Lake Park Foot Bridge – Peer Assessment

**Lake Park
Milwaukee, Wisconsin**

June 28, 2016

ONE rehabilitation option characteristics.

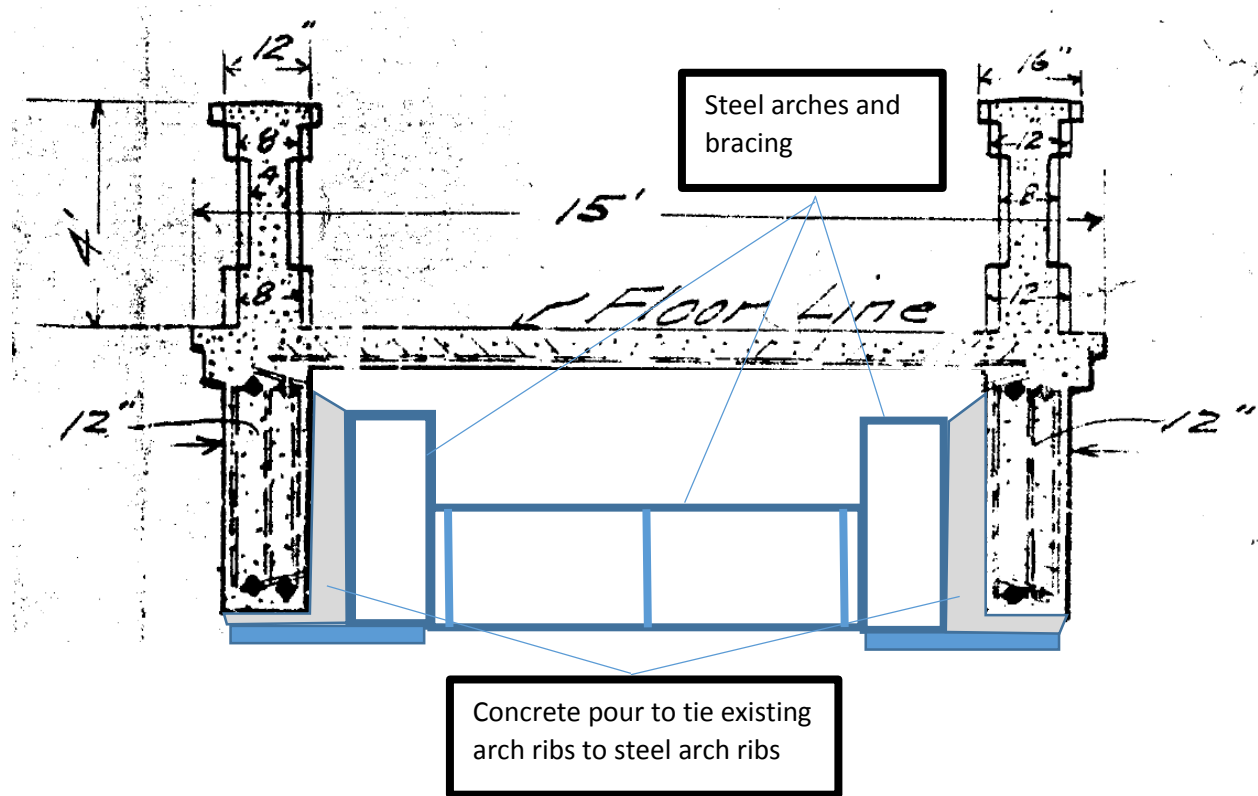
One of the concerns Graef highlighted in their report was that the arch ribs would reach the end of their service life after another 15-25 years. We concur with Graef that the existing arch ribs would likely be compromised to a significant degree, if simply patched as they have been in the past. The corrosion on the Kahn bars would continue and the spalling would continue.

To address this service life concern, we believe a new structural steel framework (including steel arch ribs) could be constructed just inside of the existing arch ribs. The steel arch ribs would be galvanized to provide some passive cathodic protection to the Kahn bars in the existing arch ribs. In addition, a support plate would be detailed under the existing arch ribs to prevent any future spalls from dropping below. The support plate would function much as a lintel does in masonry construction. The steel

framework could be designed to carry all the loads between the abutments or some smaller fraction. Resulting in a reduced load demand for the existing arch ribs.

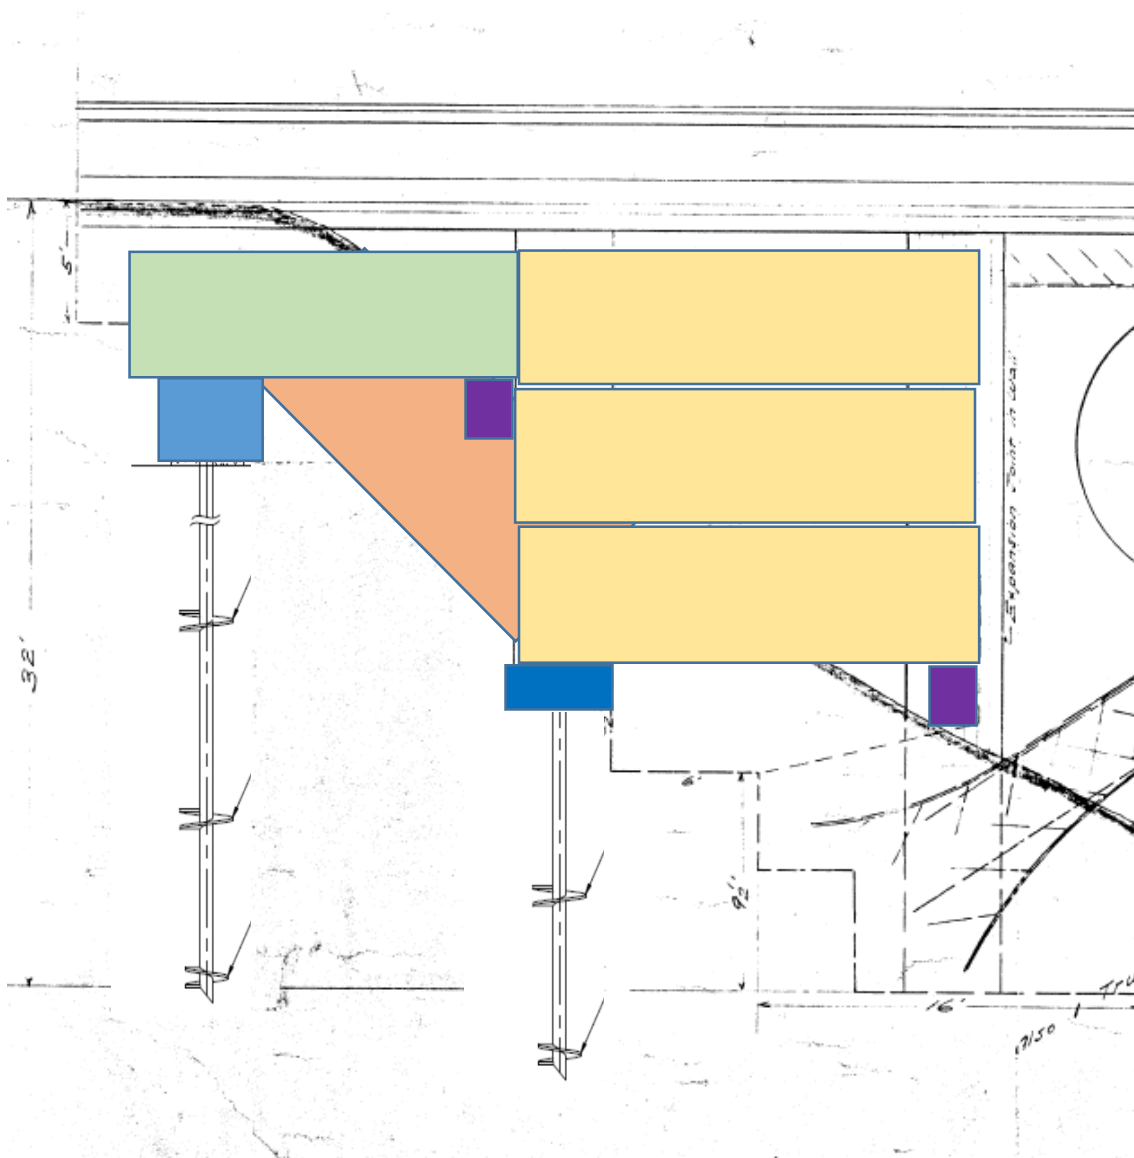
The abutments are in extremely poor condition and in a difficult to access location. There is extensive deterioration in both abutments that includes shearing of the vertical walls due to unbalanced earth pressures.

A handful of box culvert sections oriented vertically would be used as the “backbone” to support wall elements. These could be stepped to mimic the existing wall foundation steps. The sections would be “stitched” together with galvanized threadbars to create a “jumbo” beam that spans from the vertical wall over the thrust block to the supports with the helical anchors.

The abutment beam consists of a purple reaction pad constructed on the top of the thrust block. It includes a dark blue footing to support the yellow box culvert sections. After the yellow box culvert sections are in place a purple support block would be cast against the yellow box culvert sections. The vertical helical anchors are envisioned to reach a competent geotech level at the same level as the bottom of the thrust block. Atop the helical anchors a pile cap is cast. Upon the pile cap and the second purple block the green box culvert section is installed. The last step in the construction of the “mega” beam is the infill triangle wall (light orange).
